Subdivision and Land Development Cover  
Page for SLD #08-22

Project Name: Dan Lepore & Sons Realty  
Assoc, LP

**RE: SLD#08-22, 501 Washington, Conshohocken, PA  
Major Land Development Sketch Plan, Self-Storage Facility and Offices  
Zoning Ordinance Compliance Review Letter**

**RE: Sketch Plan Review**  
**501 Washington Street**  
**Whitemarsh Township, Montgomery County, PA**  
**S/LD # 08-22**  
**Our Project Number 2022-04053**

**EXISTING FEATURES PLAN**

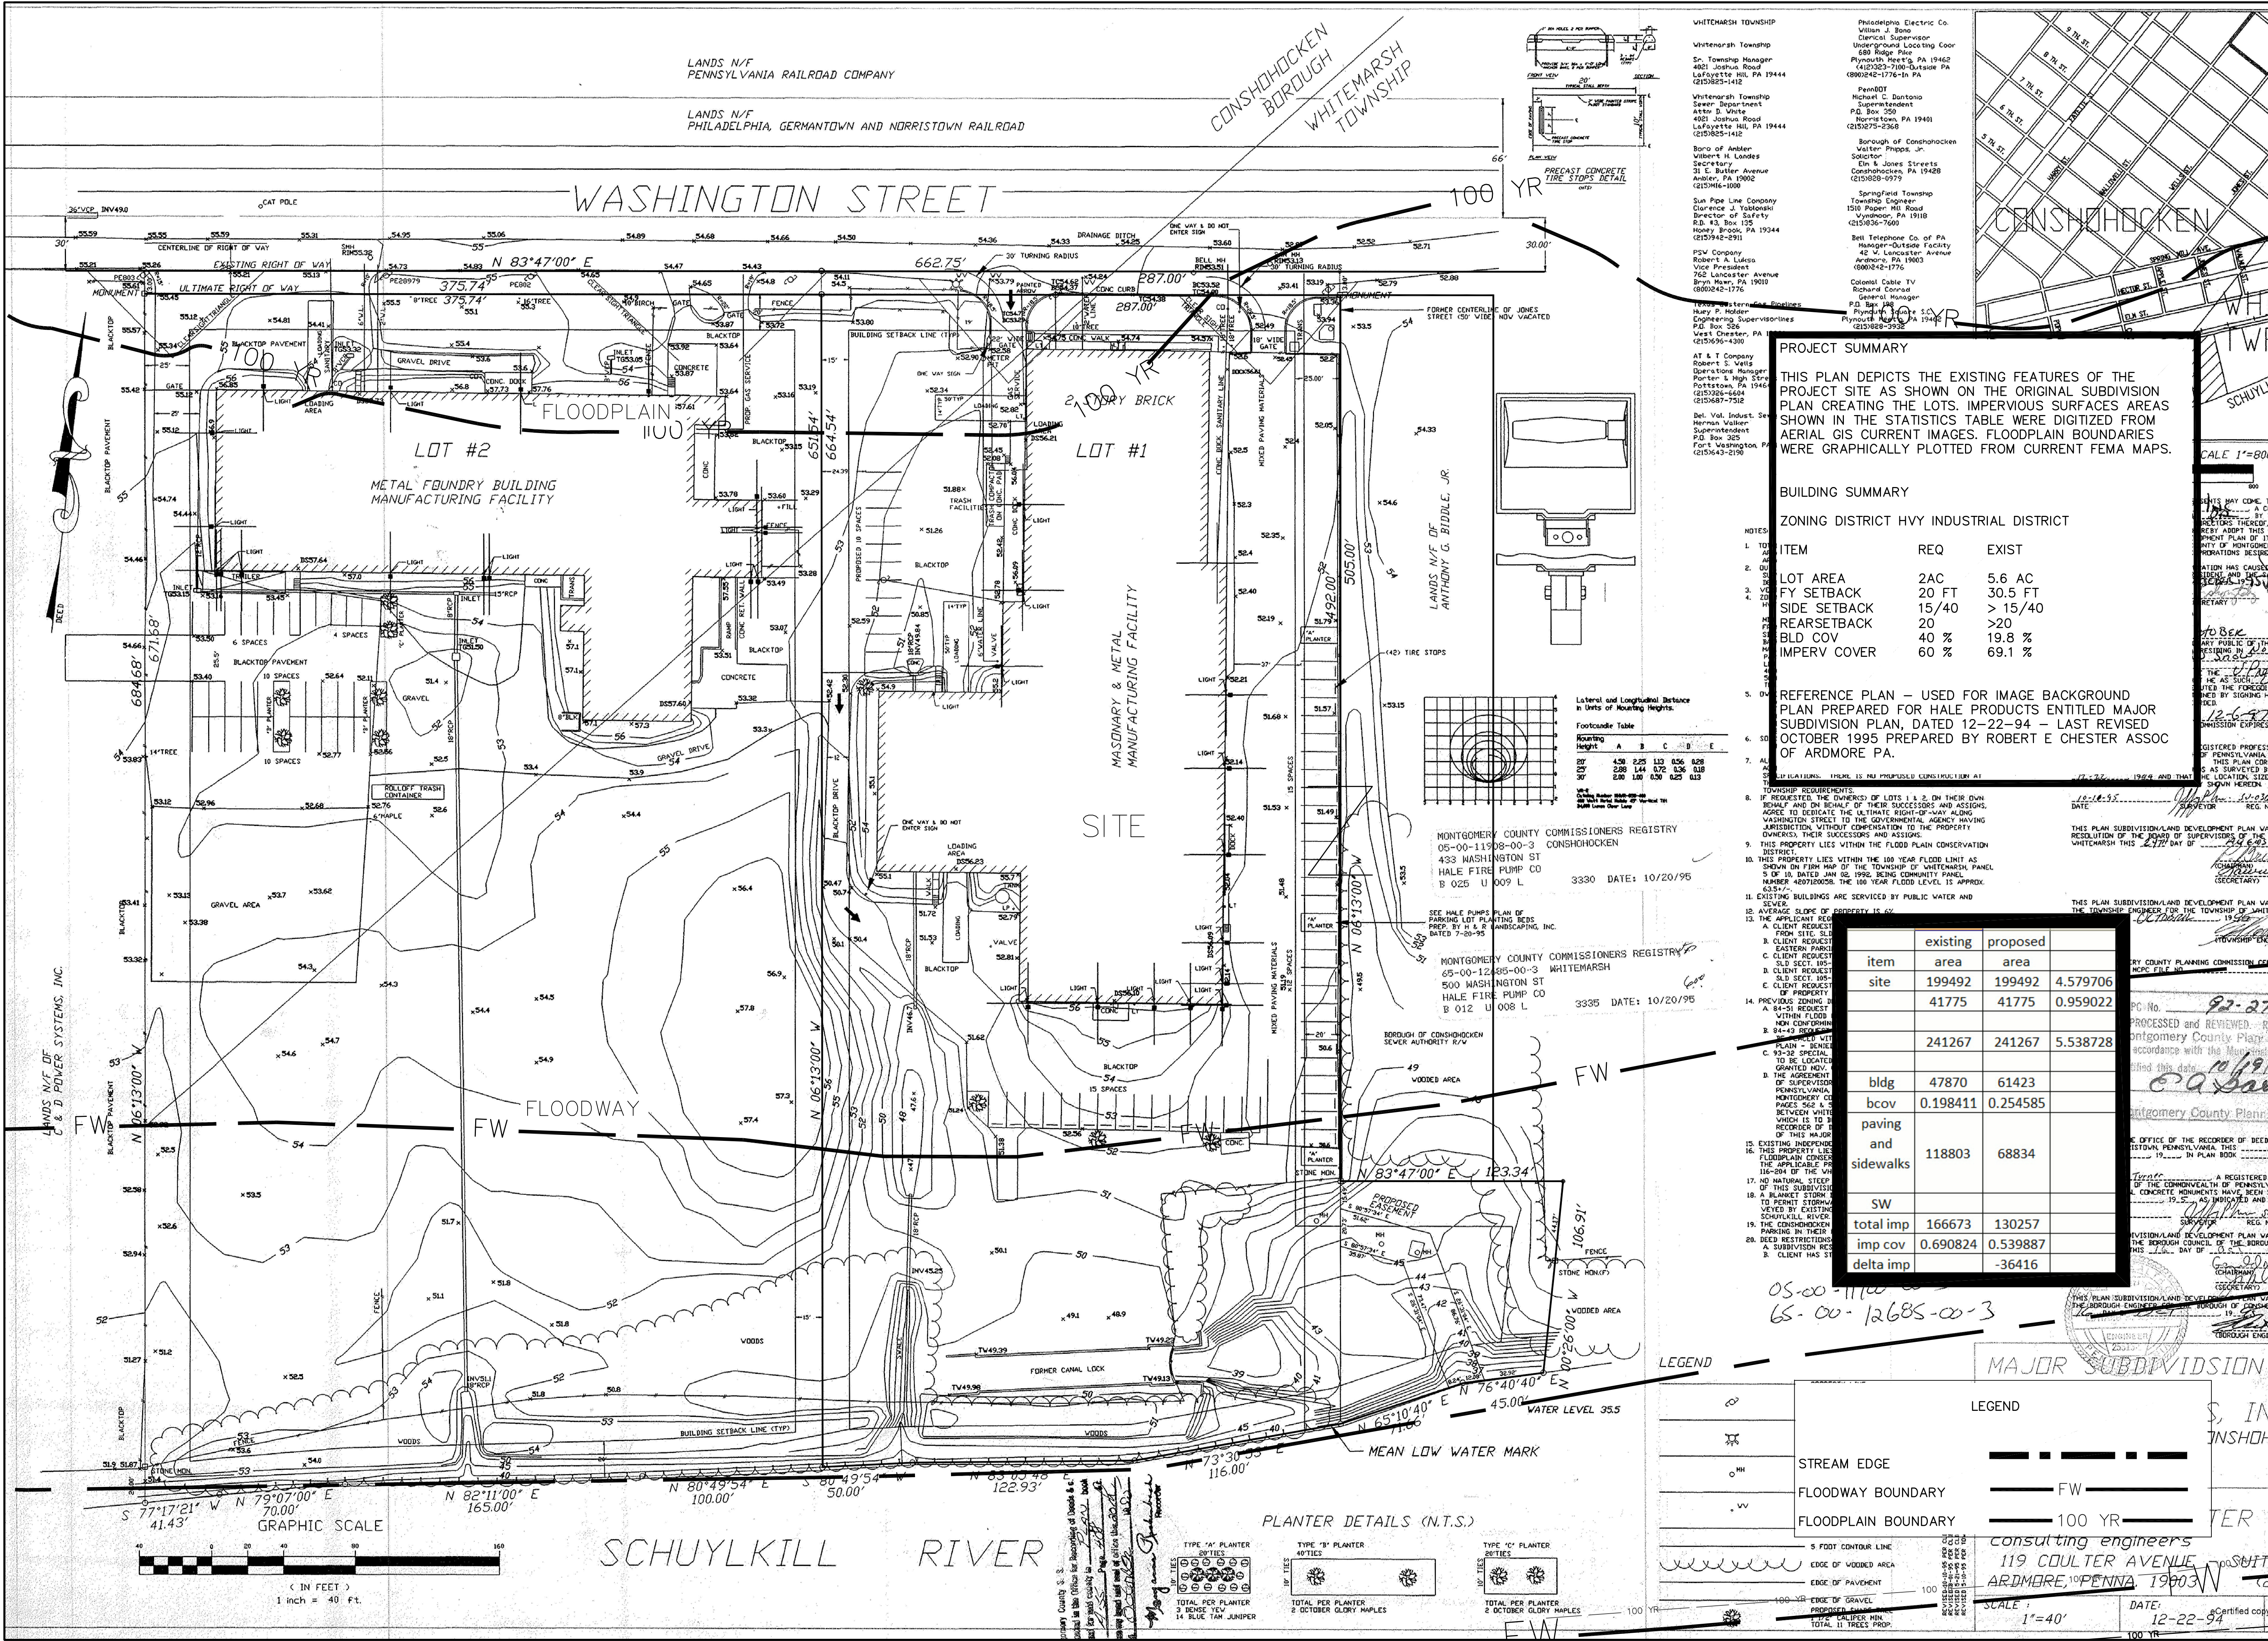
14. **§116-279.B.1.** A zoning requirement and compliance table for RDD-1 should be shown on the sketch plan in addition to the HVY table.
15. **§116-281.3.A.** This section requires a building setback of at least 20'. The plan shows a setback of 40' but states that the proposed setback is 120' in the zoning table. Clarification should be made on the plans.

5. 105-20(B)(2)	The line representing the Floodplain Boundary must be revised in order to be consistent with FEMA Flood Insurance Maps and Surveys, which designate the base flood elevation as being located along the contour line representing an elevation of 60.

Attachments:  
Aerial & Site Plan

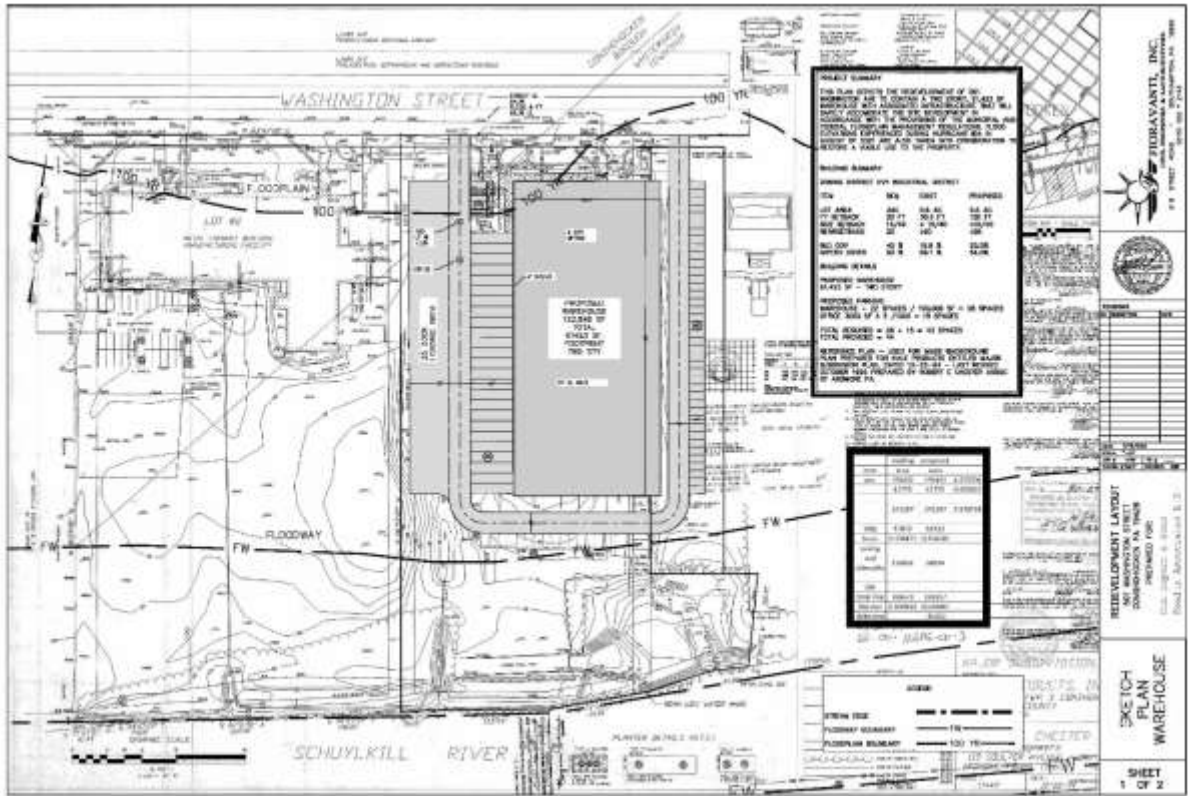
We are reluctant to support the submitted sketch plan for the redevelopment of the former industrial property as a two-story warehouse and its related storage of tractor-trailers and parking. The proposed redevelopment is inconsistent with both the county's and township's future land use vision for redeveloping the former Schuylkill Riverfront industrial sites.
